City of Boise ADA
Assessment

Appendix A-Lowell Pool

Report #TO20-B004

ID: 3775 **Facility:** Lowell Pool

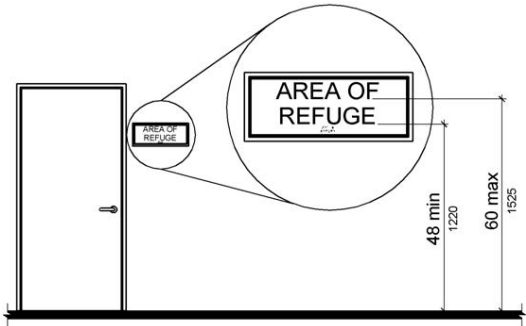
2010 ADA Standards for Accessible Design Codes: §216.2, §703
There is no tactile sign identifying the permanent room.

Install tactile signage on the latch side of the doorway at a height of 48” minimum to 60” maximum above the floor, identifying room by name or room number.
Signs shall be Braille with raised lettering and should be placed on the wall in the center of an 18"x18" clear floor space.

ID: 4462 **Facility:** Lowell Pool

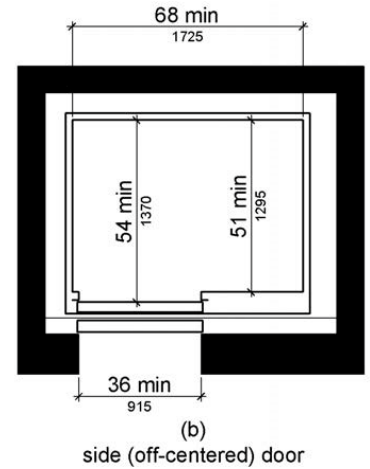
The stairs are not accessible for persons in wheelchair.

Construct a 60"x60" elevator with a 36" wide door connecting the pool deck to the proposed accessible locker rooms. Controls shall be installed at 48" maximum above the floor and emergency controls at 38" above the floor. Ensure car position indicators provide verbal announcements of stops. Floor designations shall be provided on both hoistway door jambs and a tactile star shall be provided on the main entry

ID: 3048 **Facility:** Lowell Pool

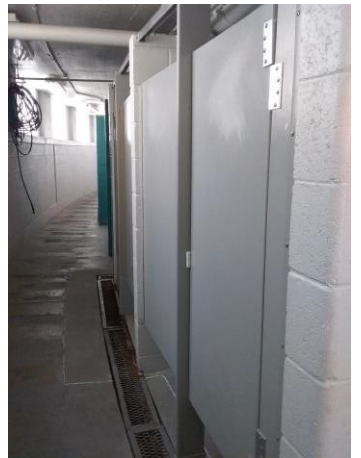
There is not an accessible shower or stall provided in the men and women's locker room. The shower dimensions do not meet the requirements for a transfer type shower at 43"x31". The stalls provided are too small to be accessible.

Due to the historic nature and limited space of the facility, consider constructing an adjacent facility containing an accessible locker rooms, showers, and restroom stalls.

ID: 3609 **Facility:** Lowell Pool

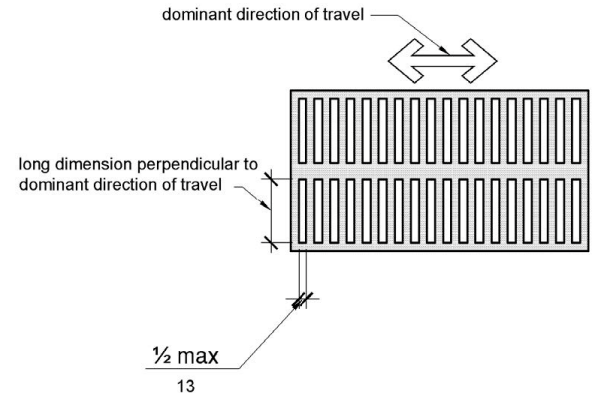
The grates in the men and women's locker room path are not stable.

Replace the grates throughout the locker rooms and ensure that they are secure and stable. Ensure that the openings in the grate is less than 0.5”.

ID: 3412 **Facility:** Lowell Pool

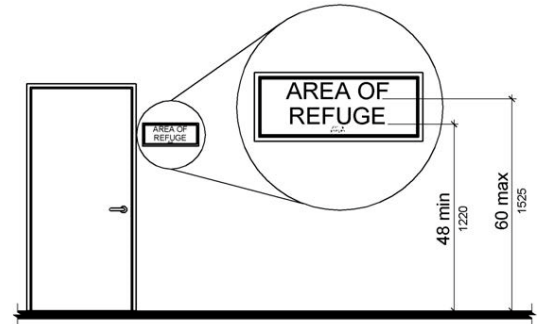
There is no tactile sign identifying the permanent room.

Install tactile signage on the latch side of the doorway at a height of 48” minimum to 60” maximum above the floor, identifying room by name or room number.

Signs shall be Braille with raised lettering and should be placed on the wall in the center of an 18"x18" clear floor space.

ID: 3254 **Facility:** Lowell Pool

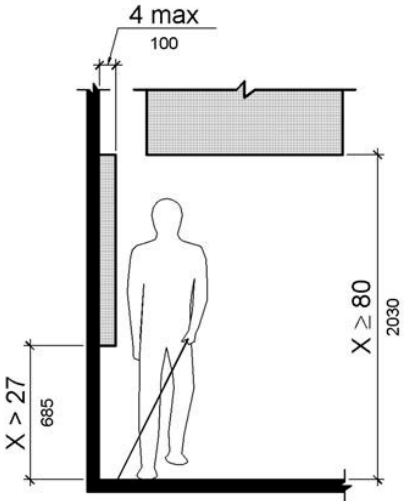
2010 ADA Standards for Accessible Design Codes: §307.2
The hose protrudes 6" into the circulation space at 63" above the floor.
The air conditioning unit protrudes 7" into the circulation space at 78" above the floor.

Recess the hose and air conditioning unit so they protrude a maximum of 4", lower them so the bottom edge is 27" maximum above the floor, or place a cane detectable object beneath it.

ID: 3472 **Facility:** Lowell Pool

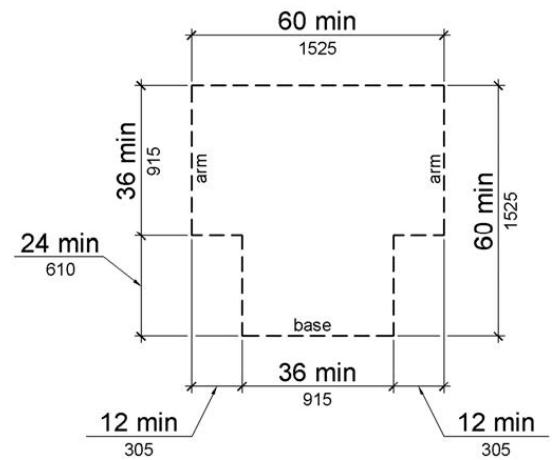
There is not an adequate turning space in the men's locker room.

Expand the space to provide a Circular or T-Shaped turning space. The circular turning space shall have a minimum diameter of 60".

The T-Shaped space shall be 60" square minimum with arms and base 36" wide minimum. Each arm shall be clear of obstructions 12" minimum in each direction. The base shall be clear of obstruction 24" minimum.

ID: 3426 **Facility:** Lowell Pool

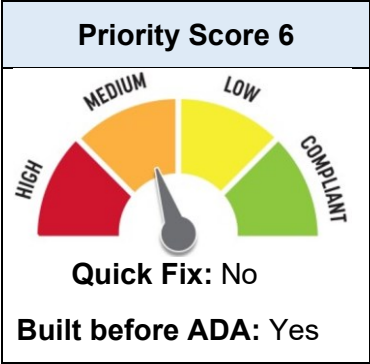
2010 ADA Standards for Accessible Design Codes: §302.1, §305, §902.4
The picnic tables are not compliant because there is no wheelchair seating available. There is not a firm, stable, and slip resistant route to the picnic tables.

Install a new accessible picnic table at a minimum height of 28" and maximum of 34". Provide knee clearance that is a minimum of 11" deep at 9" above the floor and 8" deep at 27" above the floor.
Construct a firm, stable, and slip resistant accessible route with a maximum cross slope of 2% and maximum running slope of 5%.

ID: 3089 **Facility:** Lowell Pool

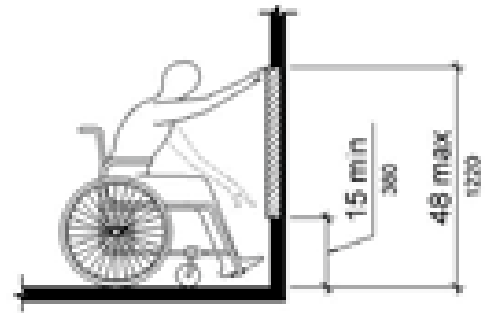
The microwave is outside of the unobstructed forward reach range at 49" above the floor.

Lower the microwave by 1" to meet the accessible reach range of 15" minimum and 48" maximum above the floor.

ID: 3090 **Facility:** Lowell Pool

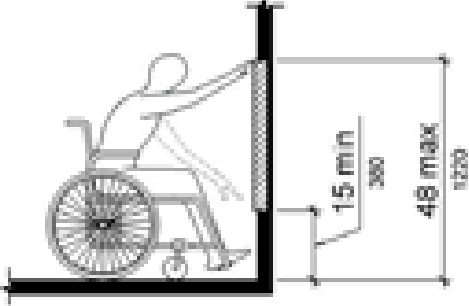
2010 ADA Standards for Accessible Design Codes: §308.2.1
The toaster is outside of the unobstructed forward reach range at 58" above the floor.

Lower the toaster by 10" to meet the accessible reach range of 15" minimum and 48" maximum above the floor.

ID: 3088 **Facility:** Lowell Pool

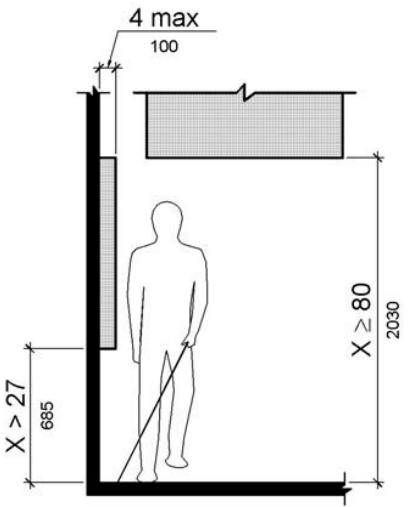
2010 ADA Standards for Accessible Design Codes: §307.2
The shelf protrudes 15" into the circulation space at 43" above the floor.

Place a cane detectable object on either edge of the shelf.

ID: 3290 **Facility:** Lowell Pool

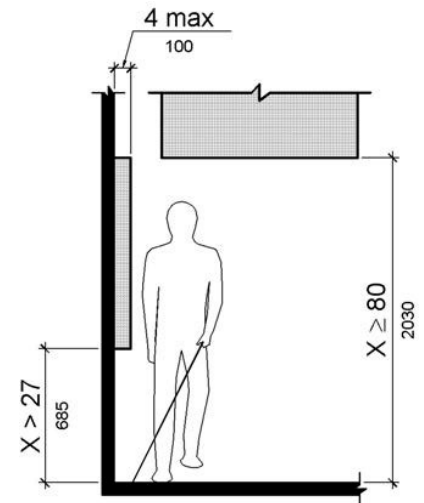
The paper towel dispenser protrudes 8" into the circulation space at 44" above the floor.

Recess the paper towel dispenser so it protrudes a maximum of 4", lower it so the bottom edge is 27" maximum above the floor, or place a cane detectable object beneath it.

ID: 3753 **Facility:** Lowell Pool

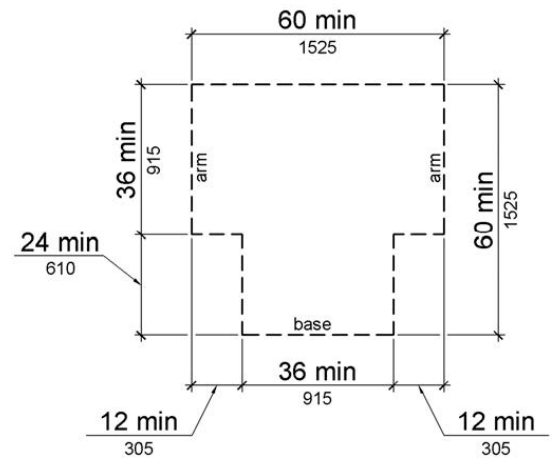
There is not an adequate turning space in the check-in area.

Expand the space to provide a Circular or T-shaped turning space. The circular turning space shall have a minimum diameter of 60".

The T-Shaped space shall be 60" square minimum with arms and base 36" wide minimum. Each arm shall be clear of obstructions 12" minimum in each direction. The base shall be clear of obstruction 24" minimum.

ID: 3374 **Facility:** Lowell Pool

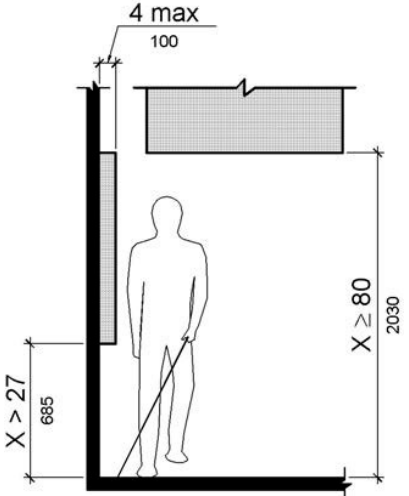
2010 ADA Standards for Accessible Design Codes: §307.2
The paper towel dispenser protrudes 8" into the circulation space at 48" above the floor.

Recess the paper towel dispenser so it protrudes a maximum of 4", lower it so the bottom edge is 27" maximum above the floor, or place a cane detectable object beneath it.

ID: 3299 **Facility:** Lowell Pool

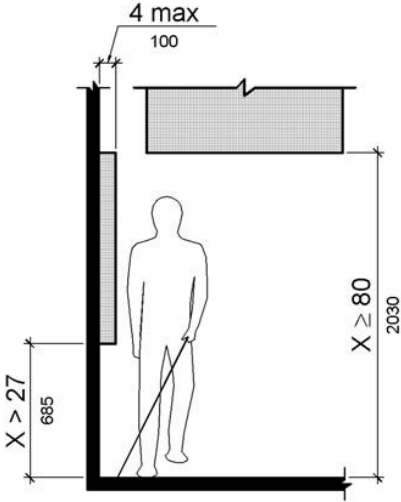
2010 ADA Standards for Accessible Design Codes: §307.2
The electrical box in the women's locker room protrudes 7" into the circulation space at 78" above the floor.

Recess the electrical box so it protrudes a maximum of 4", or place a cane detectable object beneath it.

ID: 3465 **Facility:** Lowell Pool

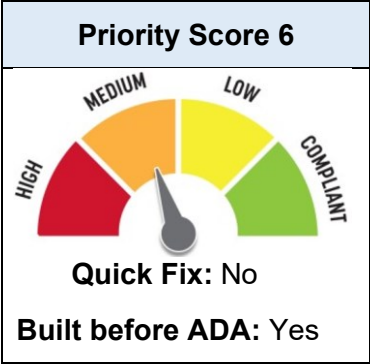
2010 ADA Standards for Accessible Design Codes: §213.3.1, §604
There is not an accessible stall in the women's locker room.

Due to space constraints, construct an accessible exterior restroom as suggested in Section 2.9 of the Lowell Report at least 60" deep and 35" to 37" wide.
